Our ref: <NC06001>
Your ref:

Cambridge Cycling Campaign

Riverside Changes

Figure 1 - Current Layout

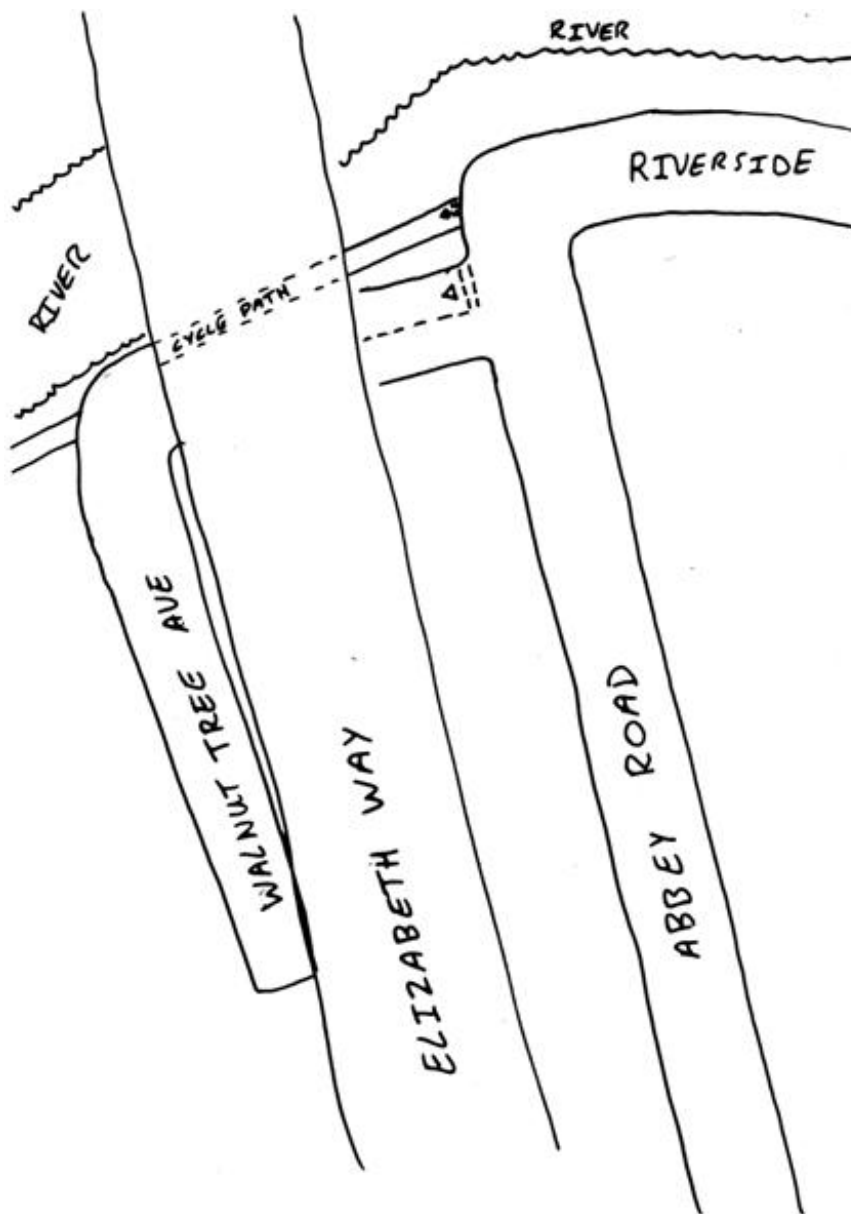
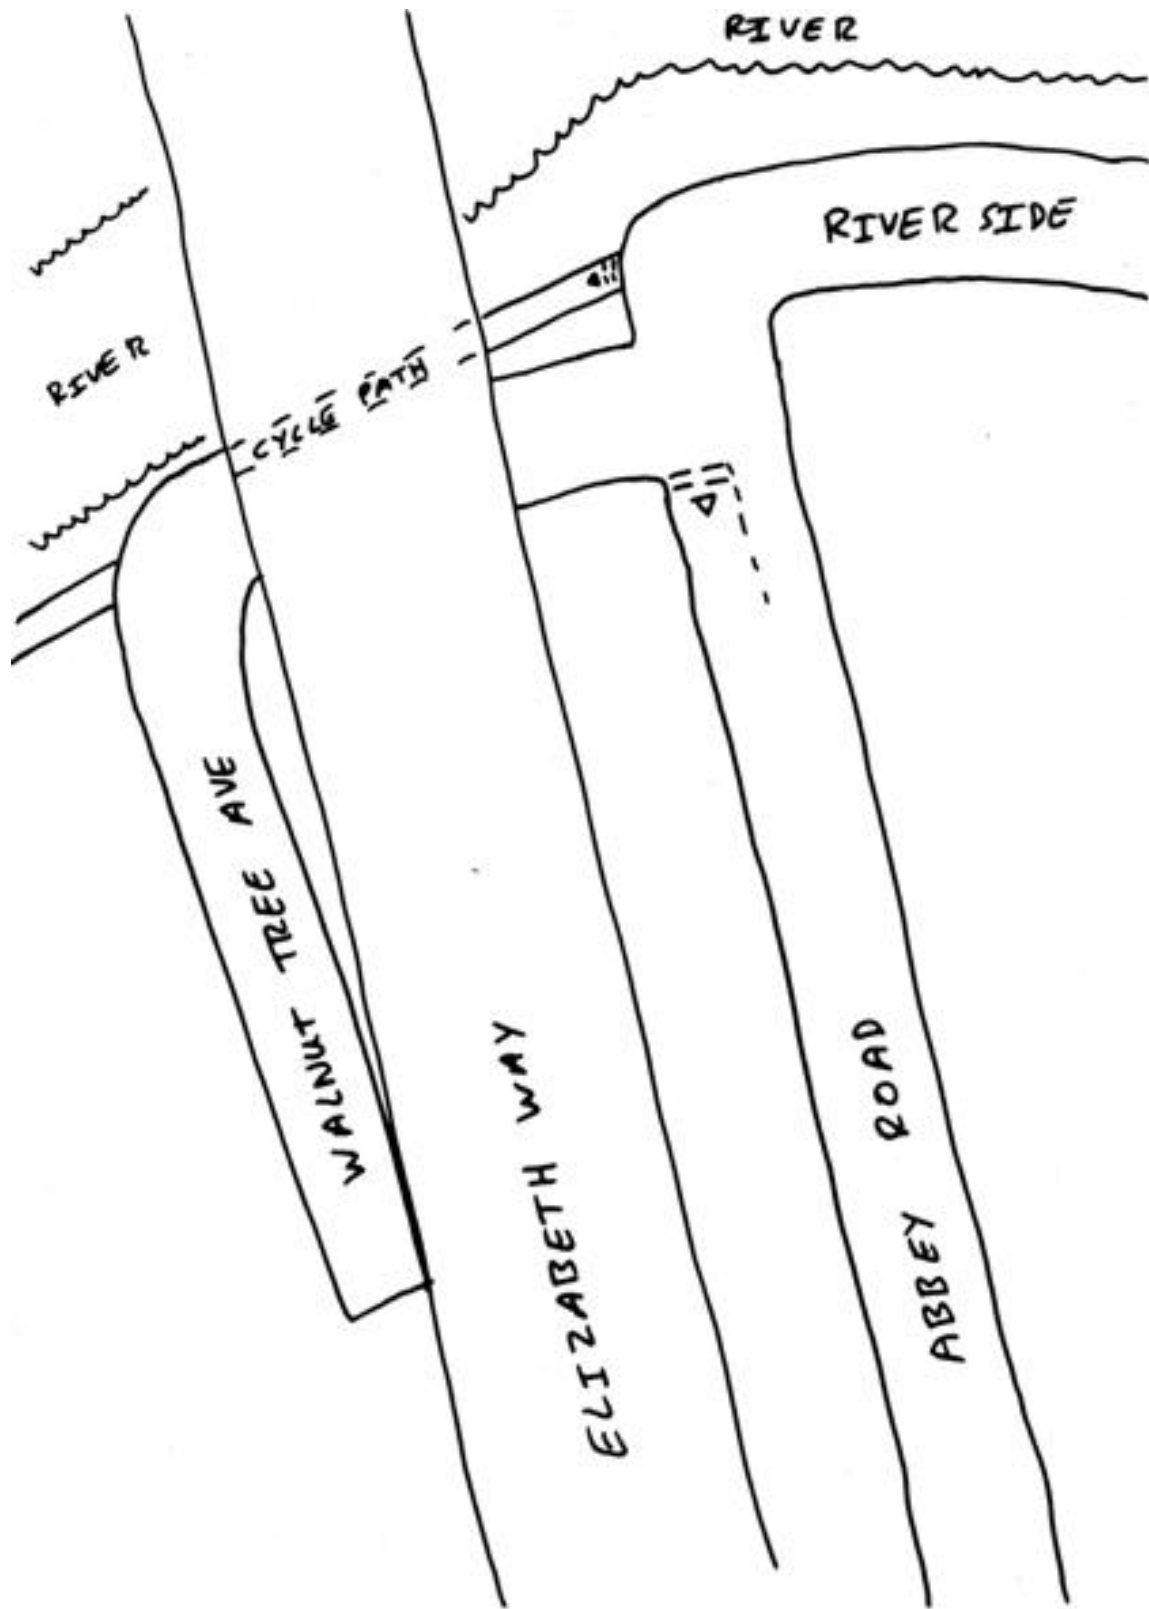
5. Whatever the new road layout make sure that cyclists are not forced to cycle close past parked cars in the 'car door opening zone'
6. Look at changing the priorities at River Lane/ Abbey Road/ Walnut Tree Avenue. The vast majority of users are cyclists travelling down Riverside, along Walnut Tree Avenue (or the cycle path) and then onto to Midsummer common (& visa versa). The current road layout does not acknowledge this (See figure1). This will be even more marked when Riverside is a no-through route to motor vehicles.

We would like to see this junction remodelled so that motorists requiring access to this dead end road would give way to cyclists. (See figure 2).
